MPE TEST REPORT

FCC ID XMR201707BG96

Product LTE Cat M1 & Cat NB1 & EGPRS Module

Report No. R1811A0536-M1

Figure 1: Schematic Designs of BG96 R1.1 and R1.2

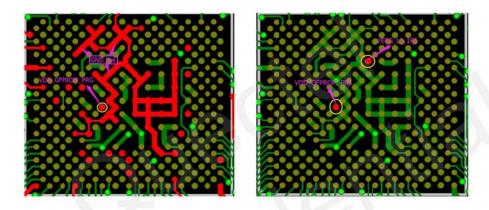
A. BG96 R1.1 does not support secure boot function

The VDD_QFPROM_PRG (N19) pin of baseband chip is for secure boot function. In BG96 R1.1, this pin is connected to ground directly, which means secure boot function is disabled.

B. BG96 R1.2 supports secure boot function

According to Qualcomm's suggestion and our customers' requirements, the VDD_QFPROM_PRG pin is connected to VREG_L3_1P8(1.8V) in BG96 R1.2 so as to enable secure boot function.

The following pictures show the schematic and PCB designs of BG96 R1.1 and R1.2.
